Reference: Responses to Request for Additional Information (Group 2) on the Application for Amendment of USNRC Source Material License SUA-1475 for the United Nuclear Corporation Mill Site, McKinley County, New Mexico (2nd submittal)

**Responses to USNRC Comments (Group 2) on the Application for Amendment of USNRC Source
Material License SUA-1475 for the United Nuclear Corporation Mill Site (2nd submittal)**

Request for Additional Information – Group 2 Safety Evaluation Report

Figure 4.3-3a: Upstream and Downstream Cross-Section Locations

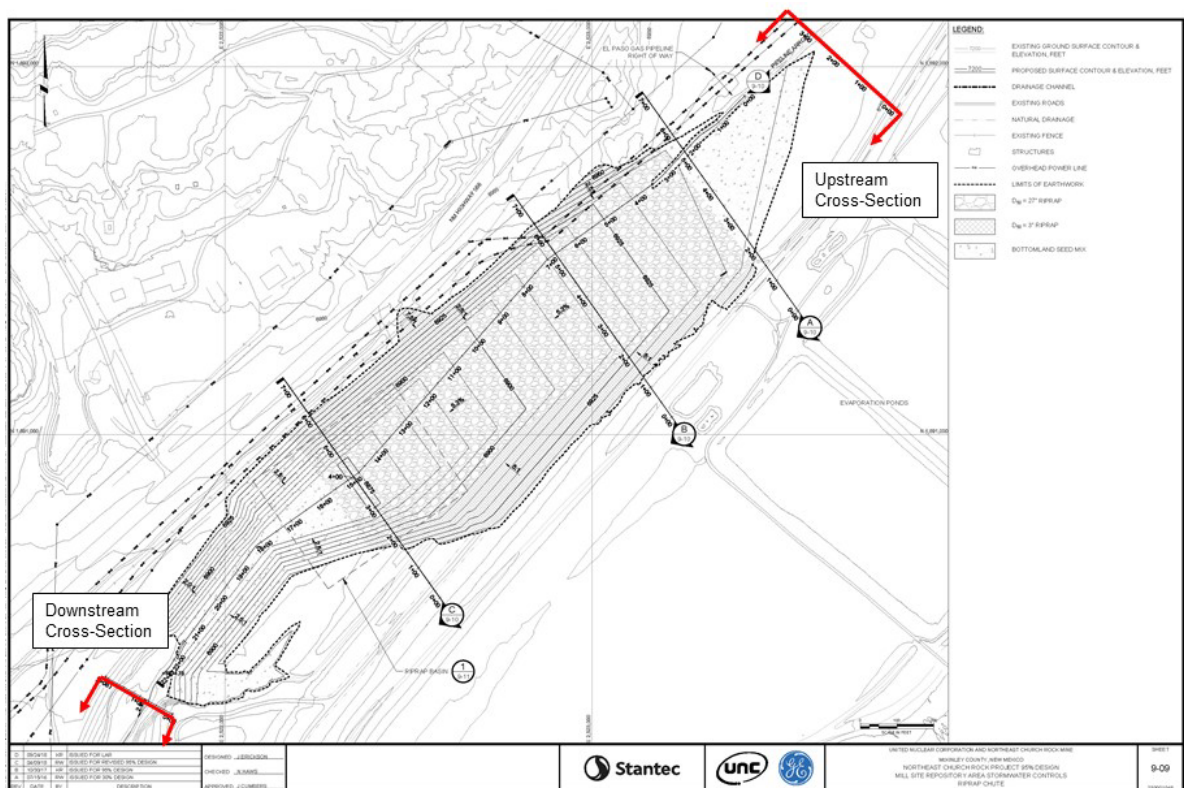
Please provide a sediment transport calculation to justify the sediment transport in the design channel of the Pipeline Arroyo between the upstream and downstream of the sunken basin limit to be in a natural balance regime. Please provide information to demonstrate that the design of the downstream channel at the sunken basin outlet can convey the sediment without a sediment deposition to migrate the channel alignment.

Stantec evaluated the sediment transport capacity upstream and downstream of the riprap chute and basin using the same methods and equations in Attachment I.4 of Appendix I, where the flow depth and shear stress are calculated based on the Manning's Equation for the 5-year and 10-year design discharges. The upstream and downstream sections evaluated are shown in Figure 4.3-3a.
